Subject: BAR Action - 110 W Jefferson Street - February 22, 2017

BAR 17-02-01 100 West Jefferson Street Tax Parcel 330180000 Christ Episcopal Church, owner/ Christie Walker, Preschool Director, applicant Proposed Fence

CITY OF CHARLOTTESVILLE BOARD OF ARCHITECTURAL REVIEW STAFF REPORT February 22, 2017

Proposed Fence

Proposed fence site

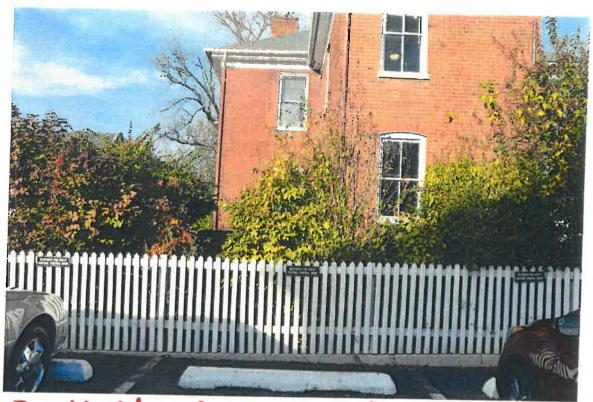
Having considered the standards set forth within the City Code, including City Design Guidelines for Site Design and Elements, Sarafin moved to find that the proposed new fence satisfies the BAR's criteria and guidelines and is compatible with this property and other properties in the North Downtown ADC district, and that the BAR approves the application as submitted, with the option to use wood picket painted white or a dark color, or iron, or black aluminum, with the height of 3 feet. Mohr seconded. Motion passed (7-0)
